REPORT

Unwatering the North Comstock Mines

ANSWERING FORTY-SEVEN QUESTIONS

A. M. WALSH,
Supt. U. C. Pumping Association

DIAGRAM 1

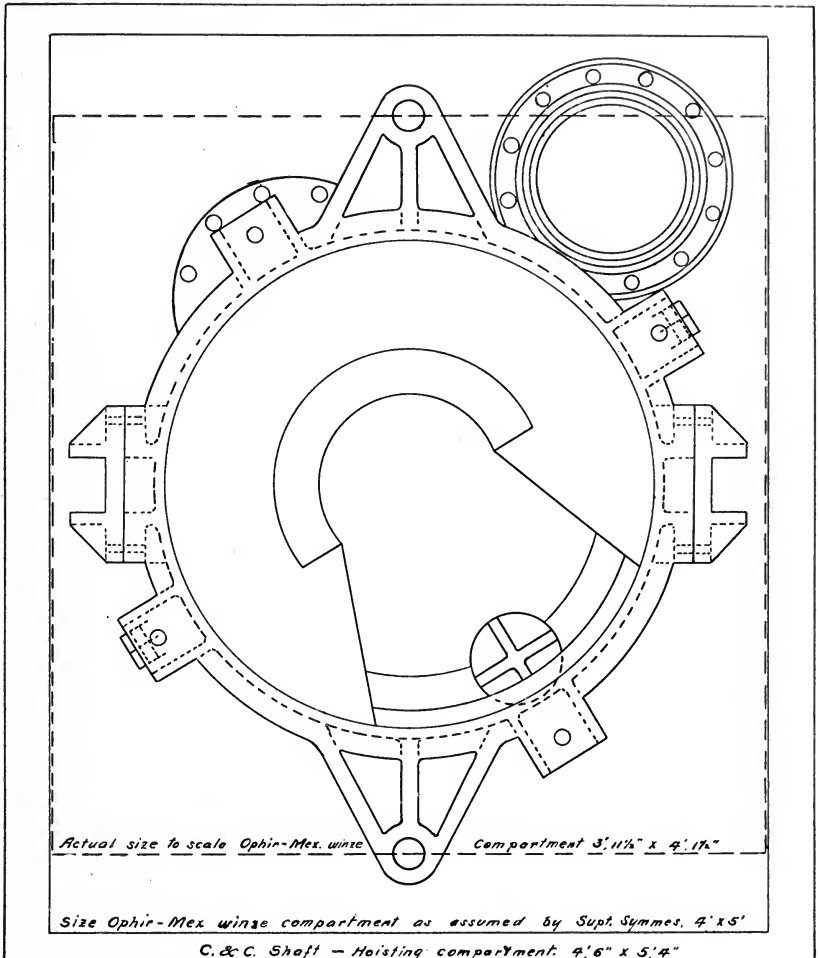
The fourth factor is one which will greatly astonish you, as it involves an error in observation of the grossest kind on the part of my predecessor in the management here, which has already occasioned heavy losses and might have caused much further loss of time and money had the former plans for unwatering the 2700 level been adopted by me. This factor is the smallness of the compartments of the Ophir-Mexican winze, which are of a size utterly precluding the passage of the electrical turbine sinkers through them.

On assuming the management I found, among the papers of the Pumping Association, a drawing of the Ophir-Mexican winze compartment, which shows it to be four feet wide and five feet long. Compartments of this size might, theoretically, permit the passage of the electrical sinker, though actually there would be serious difficulties involved in the operation.

However, a careful examination of the winze disclosed the fact that its compartments are really but 3 feet 11½ inches wide by 4 feet 1½ inches long, a circumstance accounted for by Mr. McCormick as follows: In former times each mine made its own ore cars from designs more or less dependent upon the caprices of the various superintendents. In this way it chanced that Con-Virginia used rather large cars, which resulted in winze compartments in that mine of a size, 4 feet 4 inches by 4 feet 7 inches, while Ophir on the other hand, had only small cars, for the passage of which smaller winze compartments were adequate. When you made your plans for using the electrical sinkers in the Ophir-Mexican winze, it appears that you must have deceived yourself by a failure to sound and plumb the winze beneath the water level at its collar. If you should now care to do this you will find that the compartments really measure 3 feet 11½ inches by 4 feet 1½ inches as I have stated, except in the first four feet below the winze collar, where the timbers are widened out to allow room for the installation of chairs for the cage.

Had the Ophir-Mexican Winze compartments been four feet by five feet as shown by diagram left by you in the office records, it would even then have been almost a hopeless task to pass the pumps through them. But as the compartments actually are, this would be entirely out of the question. If the pumps were hung above them as they were intended to be hung they would protrude about 6 inches into the timbers.

DIAGRAM II

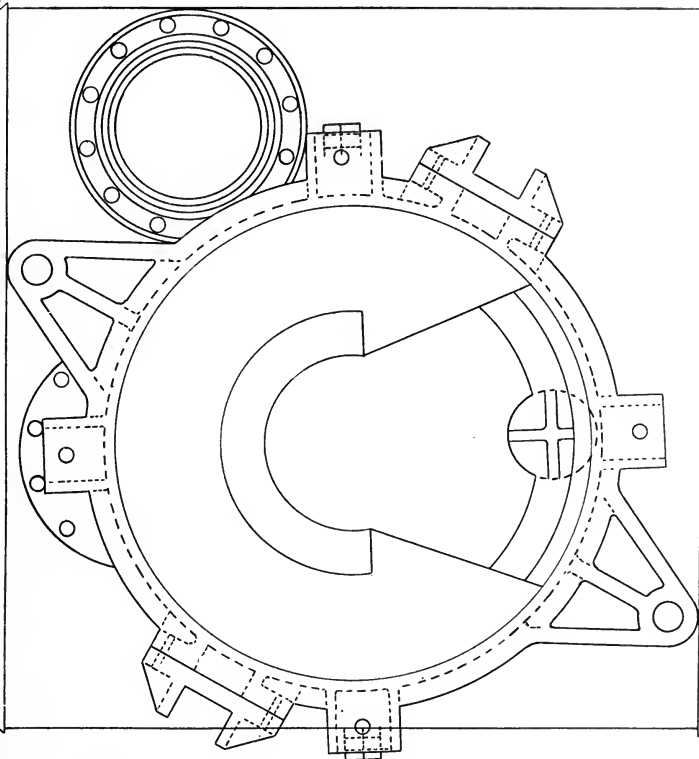
As a matter of purely academic interest I have placed a cross-sectional drawing of the pump on tracing cloth and turned it about over a diagram of the winze compartment to ascertain the most favorable position in which the pump could be presented to the winze. The result is shown in diagram No. 2, and even so, the pump would protrude a minimum of $2\frac{1}{2}$ inches into the timbers, assuming a theoretical clearance of nothing for the other parts of the pump. However, we cannot venture to assume the winze is perfectly straight by any means and a pump 16 feet long would require some additional clearance to allow for this factor. Moreover, in an old cribbed winze, we can be sure some of the timbers will protrude as much as two inches; and in some places we may expect such bulges to be found on both sides. Therefore, it may be taken as an entirely safe assumption that the winze would need to have a clearance of at least six inches over an exact fit when the pump is in the most favorable position for passing through the compartment which means that at least one dimension of the winze must be as much as $8\frac{1}{2}$ inches greater than it is. But even this would only give a fighting chance to lower the pump, as a $6\frac{1}{2}$ tons pump lowered in free suspension on a cable without guides is not a sufficiently reasonable thing for consideration in conservative engineering practice.

Summarizing this fourth decisive factor it is seen that the Ophir-Mexican winze could not possibly be used for the turbine
